Letter of Objection to the development at Former Tower
Car Sales, Tower Close, East Grinstead, West Sussex
(now known as Whittaker House, 1 Leppard Walk) and
retrospective application DM/26/0432

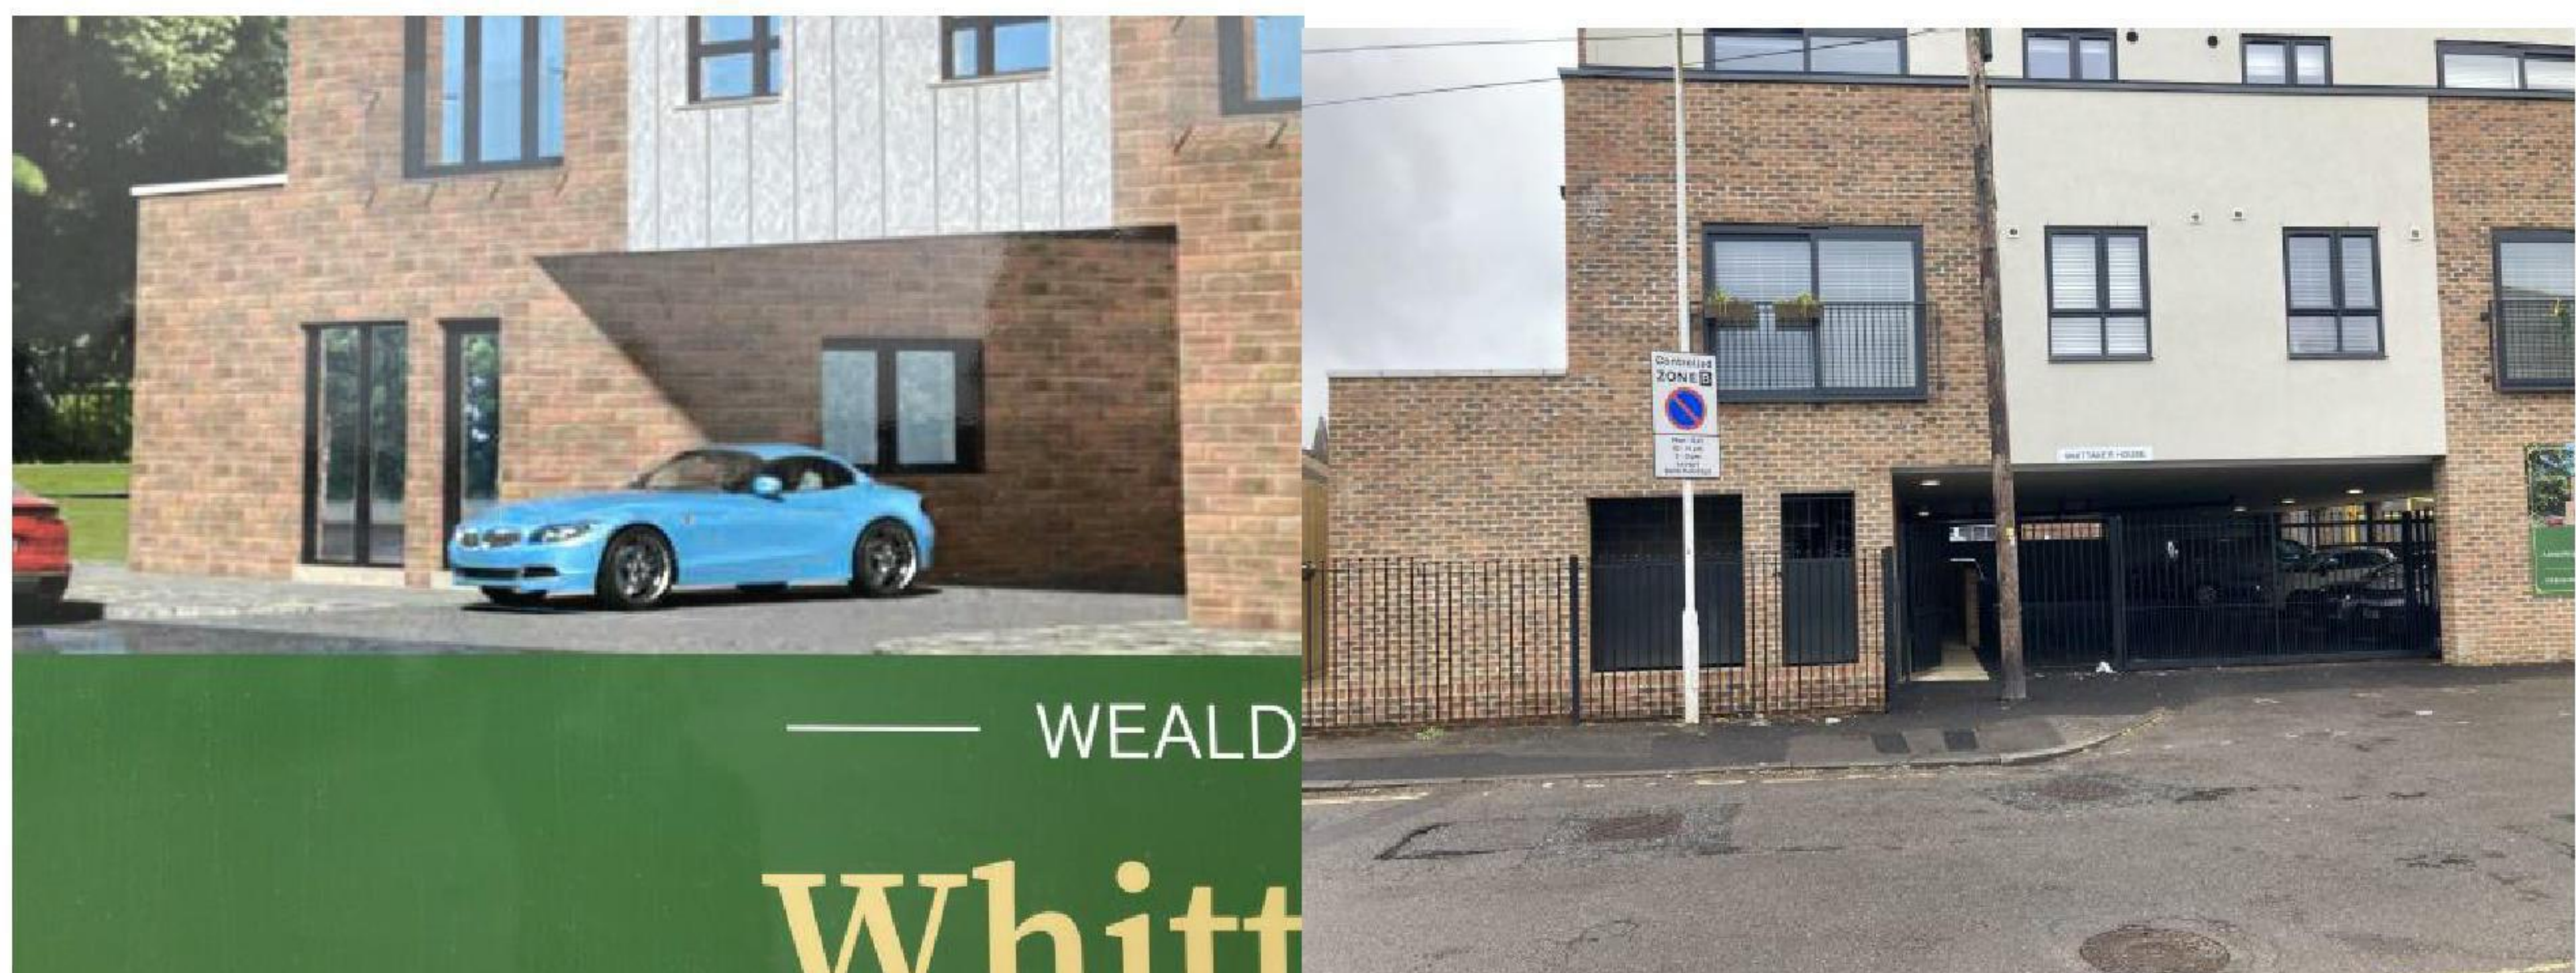
Starting with the outside of the property, Whittaker House was supposed to have a separate entrance, with a wide gated walkway to the right leading to a dedicated bike storage for 10 bikes, and 2 large refuse bins (sufficient bin storage for 8 properties). Both of these areas would lead into the entrance hallway, with the stairwell benefitting from opaque glass and entry into the undercroft.

Planning permission was granted with acknowledgement of this, and noting that resident would not have to enter through the undercroft:

The promotional material (same images as submitted plans); the current front of the building;

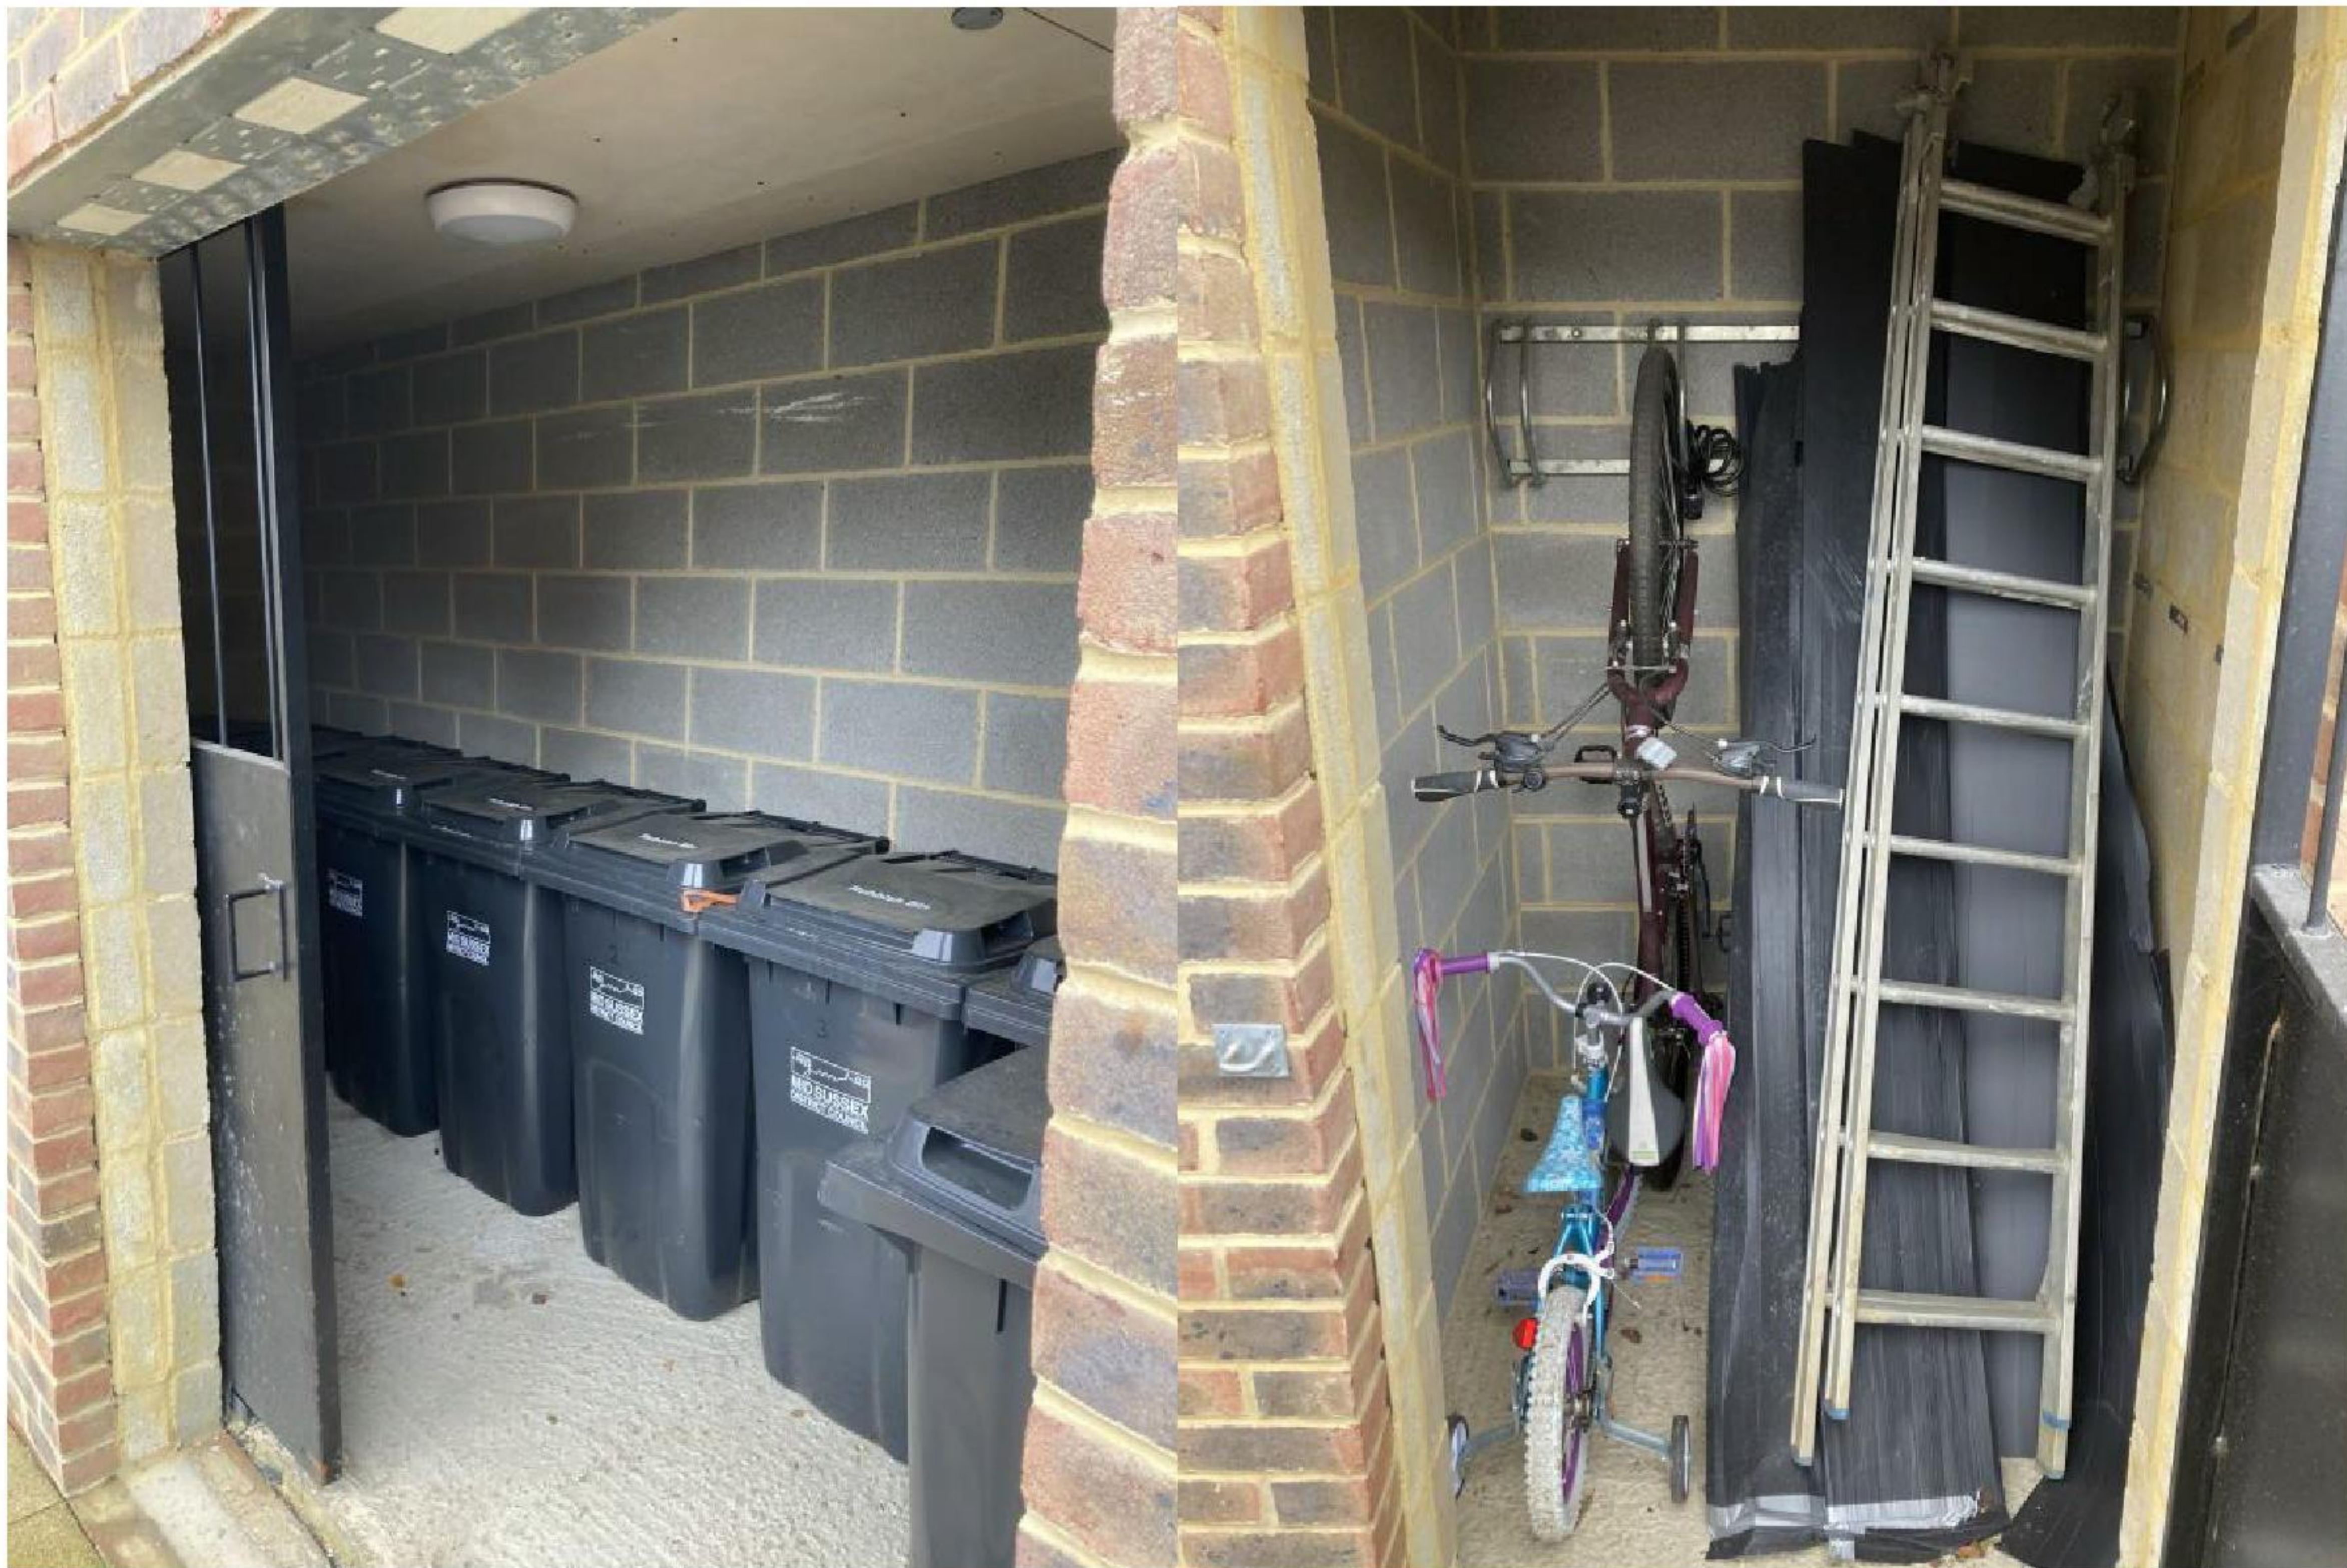
The entrance is now our 'dedicated bin and bike storage'. These are so unsuitable for the purpose as to be functionally useless. They remain unfinished, with unfinished brickwork (and bin storage) now forming part of the view for our neighbours. The bin storage area holds 8 bins, with the 9th squeezed in. Our recycling bins now live in the undercroft, as

Dedicated bin storage; Dedicated secure storage for 10 bikes

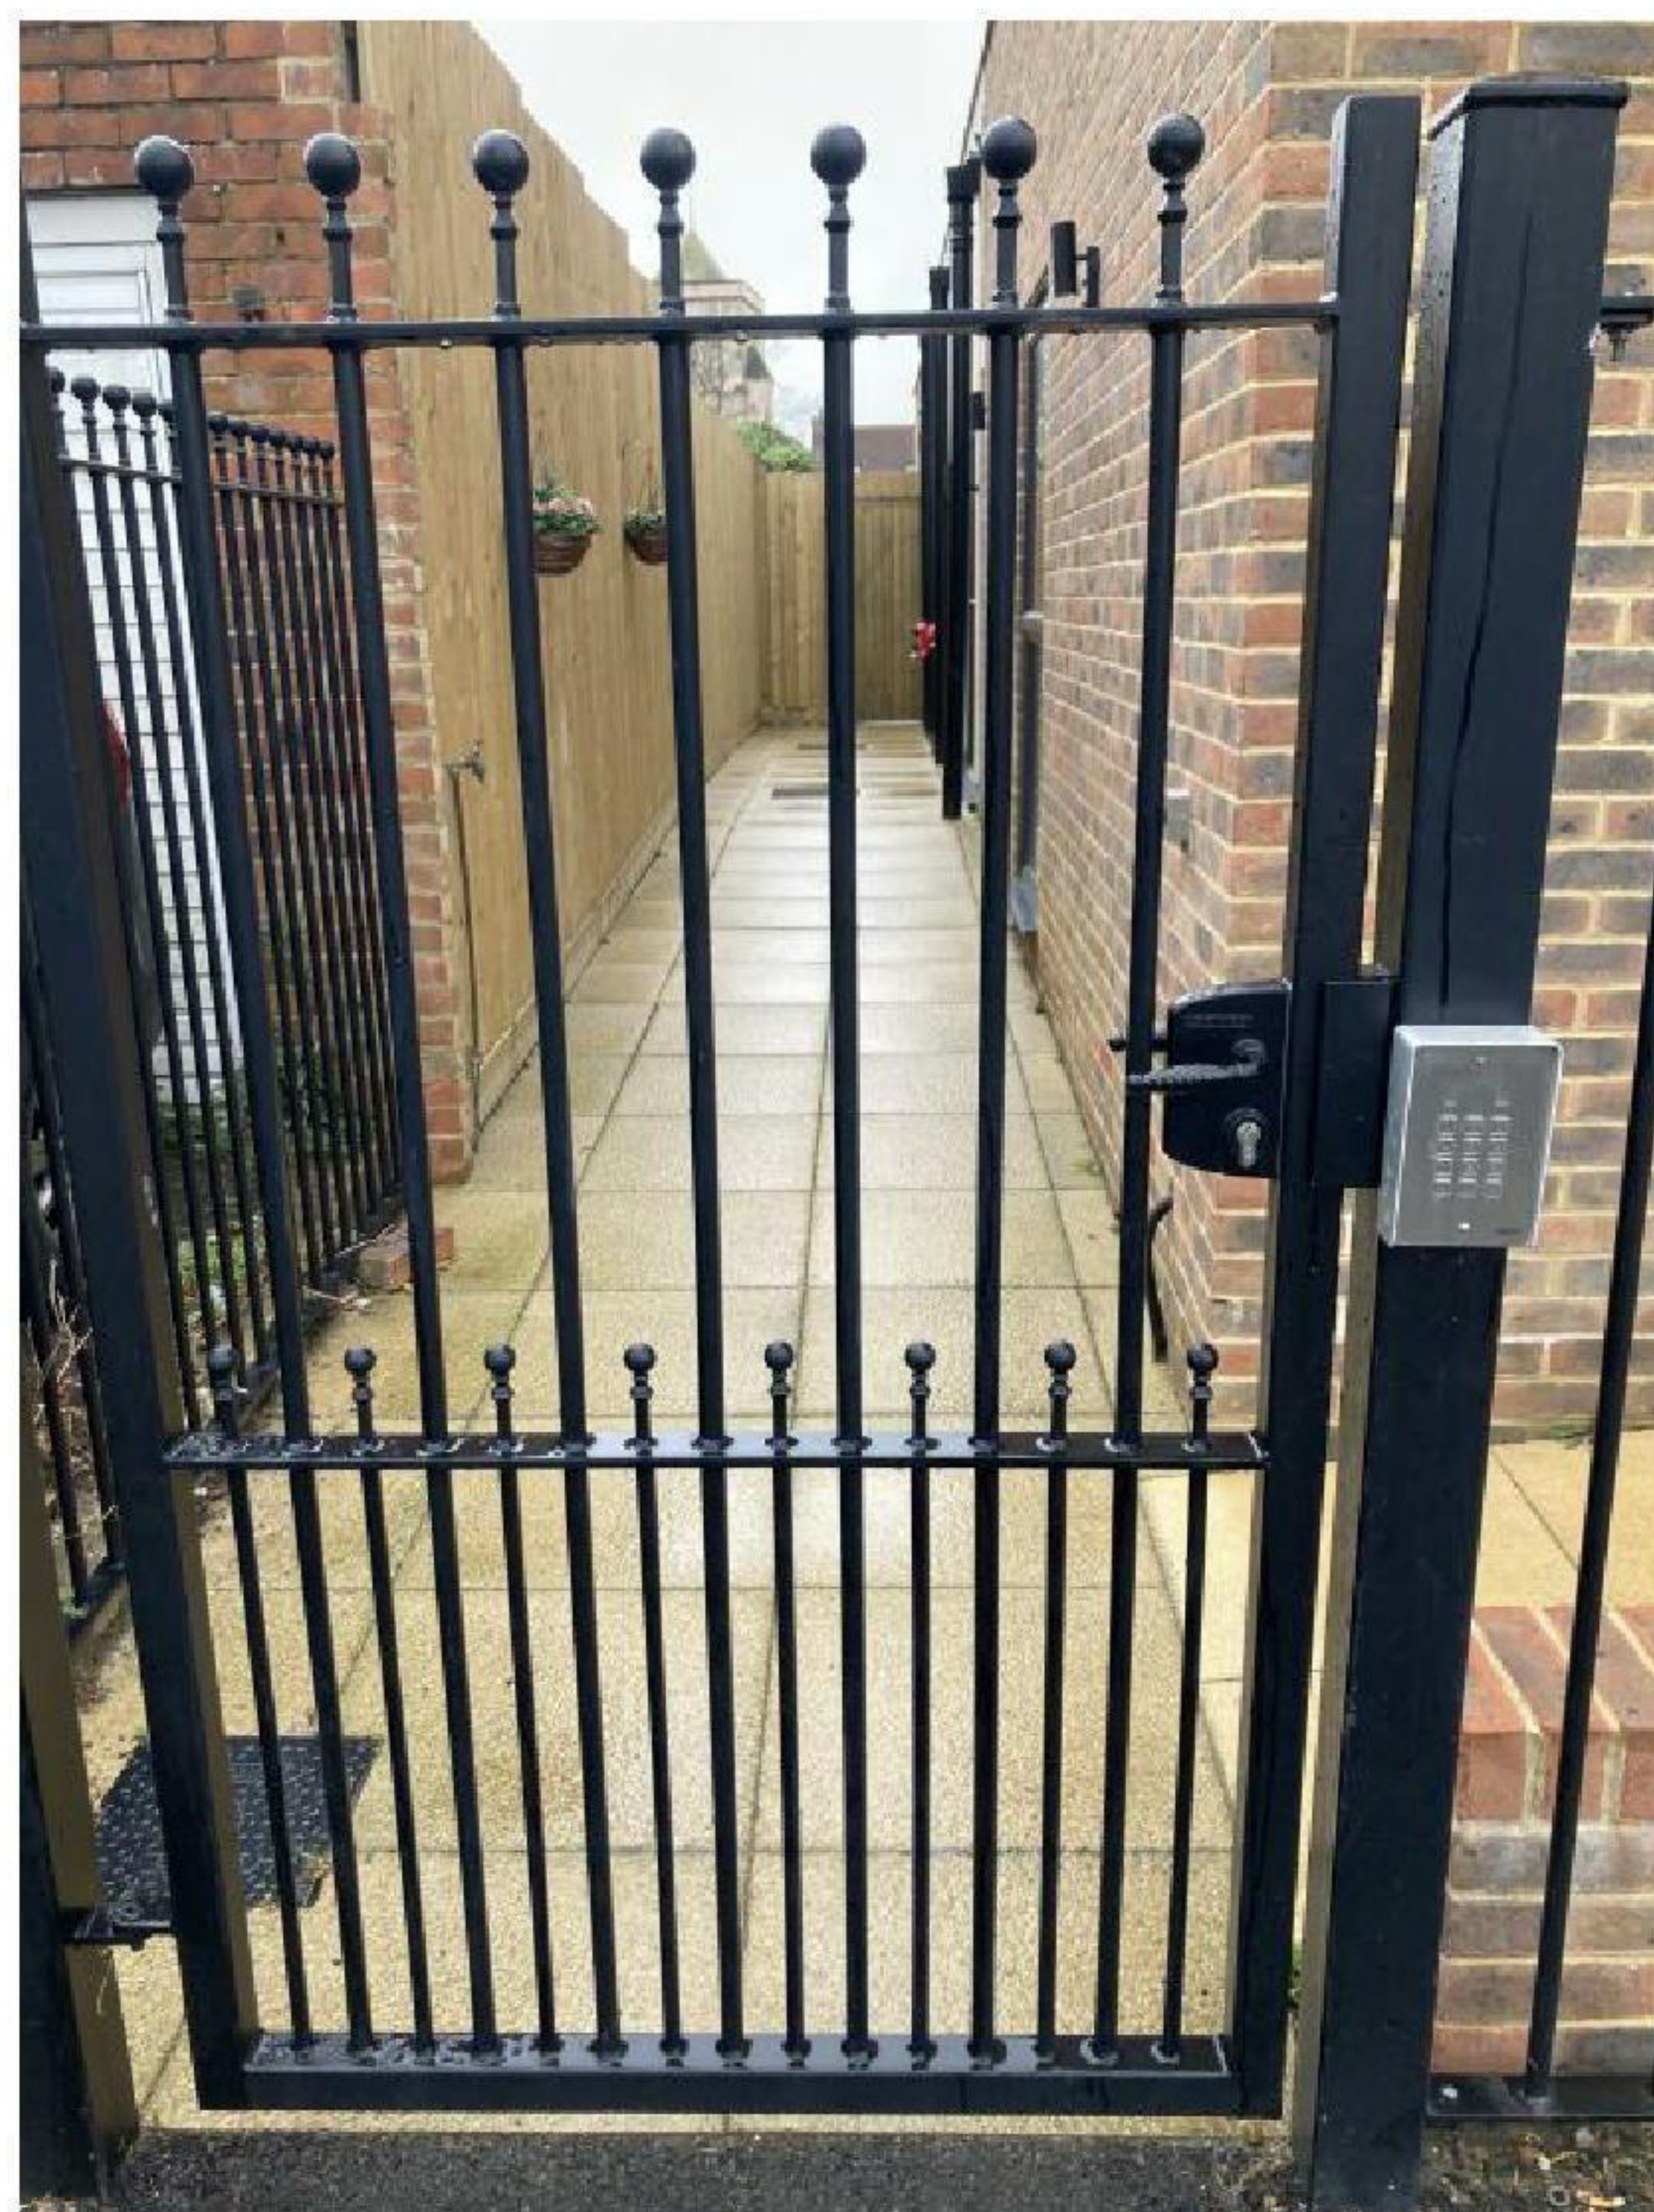
there is no 'dedicated bin storage'. The 'dedicated bike storage for 10 bikes' is honestly my favourite part of the development:

It would be funny if the property hadn't been marketed and sold as having dedicated secure bike storage, if said storage wasn't also mentioned when granting planning permission, and if several of the current freeholders hadn't purchased their property with this specific feature in mind.
